Enercept Product Bulletin #3

Created: 4/13/16

2" x 24" RIDGE STRAP (Discontinued):

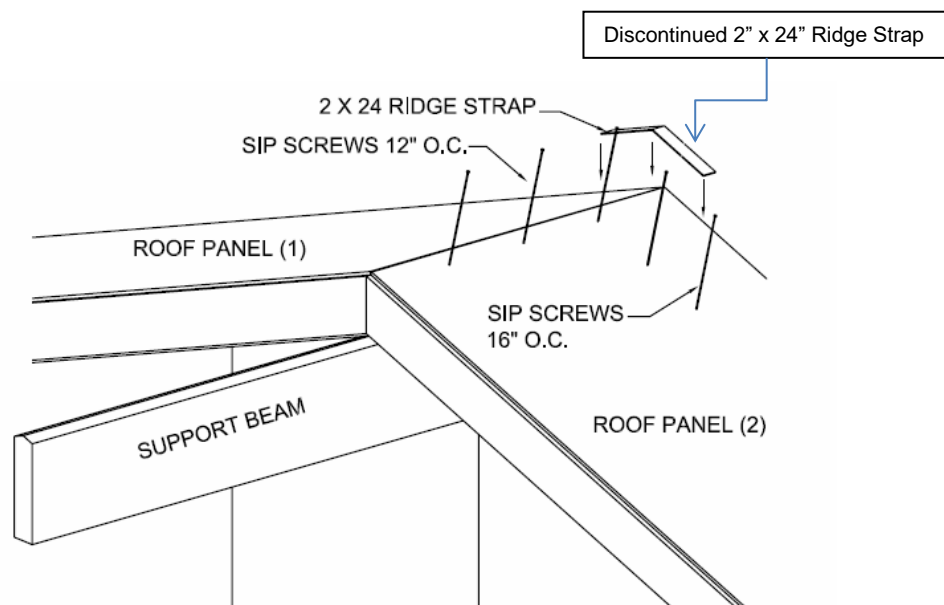
Enercept SIP construction guide has recommended the installation of 2" x 24" ridge straps in Section 8 – Structural Roof.

The 2" x 24" ridge straps have been discontinued and will not be provided as part of the Enercept SIP roof package. SIP screws/fasteners are provided and used to secure the panels into place.

Per Enercept code/listing reports, SIP screws are the approved fastener to secure panels to beams, purlins, and support walls. Therefore 2x24 ridge straps are no longer used for this purpose.

Please review Enercept final plans for your project and follow SIP screw installation instructions to assure proper roof panel attachment.
